# REV2 REFERENCE / REDESIGN IN PROGRESS

## 22 September 2026: the current print order is N1 nose only.

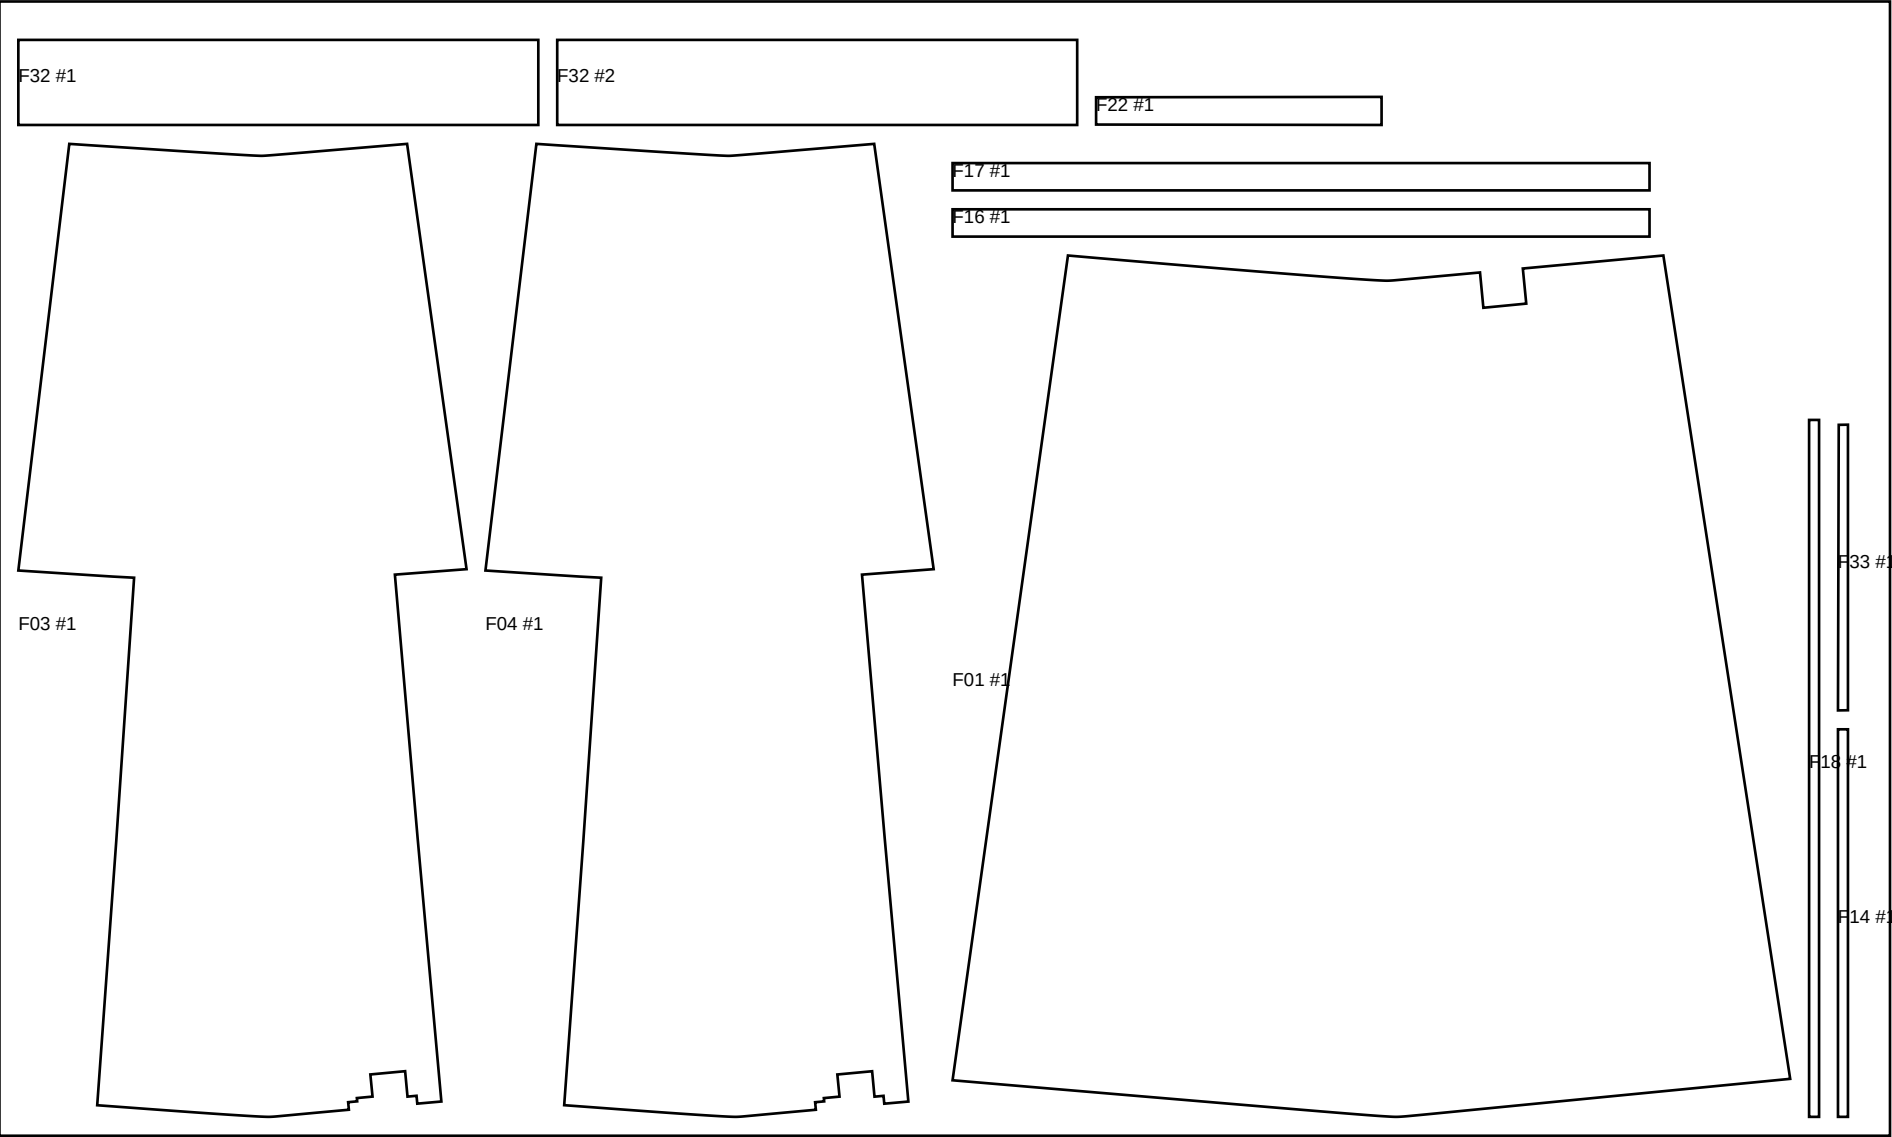
Landing gear and steering system; the old 42-piece print order; A59 cover screw holes, columns, spacers and shaped washers; the large nose pitot-access notch. Do not fabricate these from the old instructions.

N1 restores the original upper nose shell. It uses a proposed simple ledge/tape attachment and a probe passage drilled to actual hardware during assembly. It retains the original rear mating envelope.

Use Manufacturing/Nose\_Print\_N1/A59\_Nose\_N1\_mm.stl and Nose\_N1\_Print\_Guide.pdf. Quantity one, millimetres, 100%.
